HISTORIC LANDMARK COMMISSION STAFF REPORT

Jerry Erkelens Major Alteration PLNHLC-2008-00208 919 First Avenue in the Avenues Historic District October 1, 2008

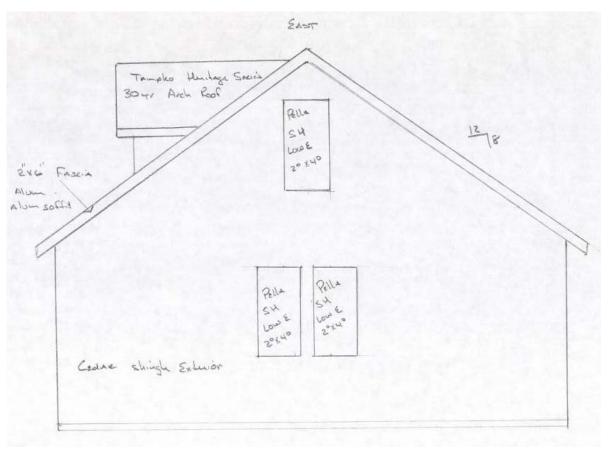
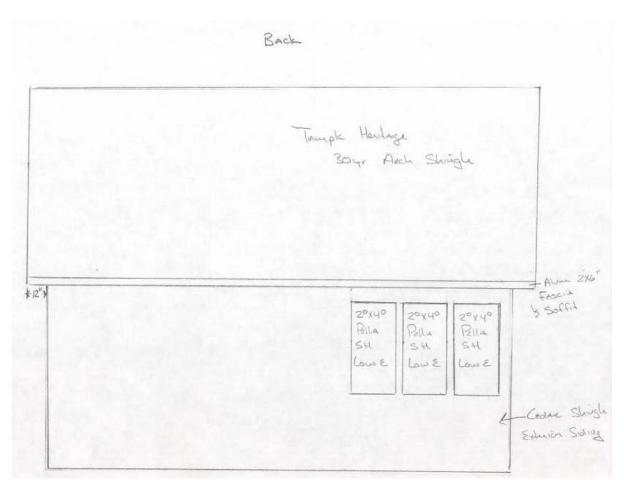
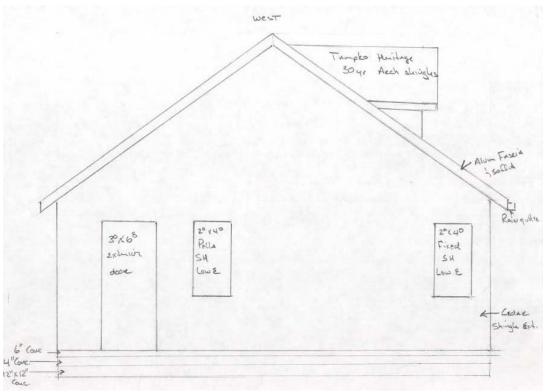
The sketch look ok, it needs the driveway taper rate dimensioned with a 3:1 taper rate.

See revision sketch.

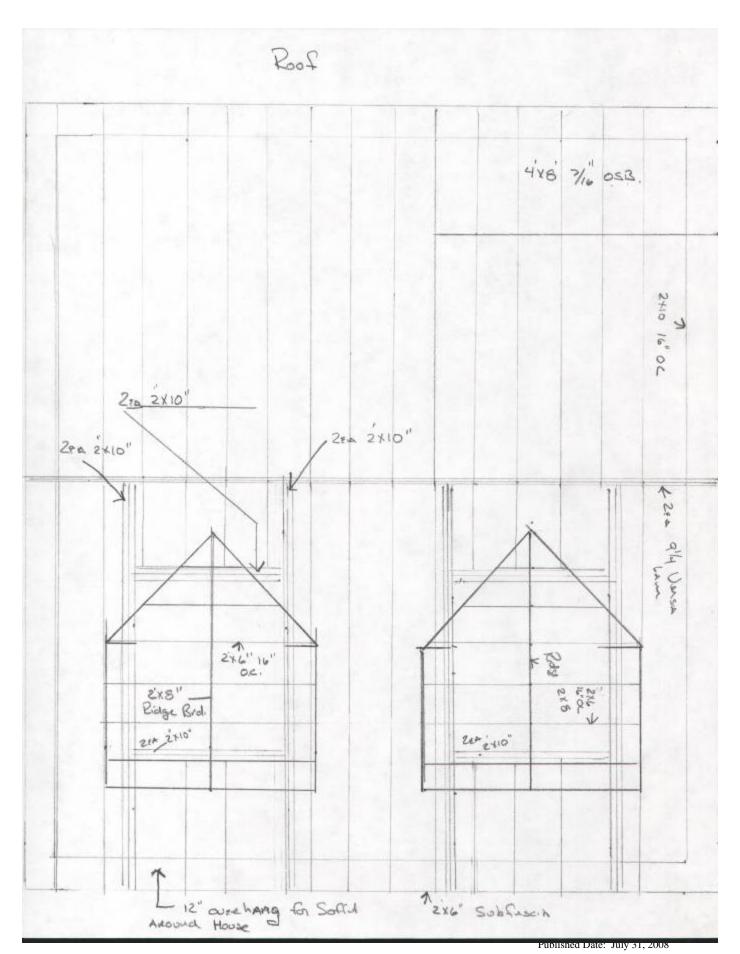
According to the applicant, the nineteen foot (19') height indicated on this plan is incorrect and should be seventeen feet (17')
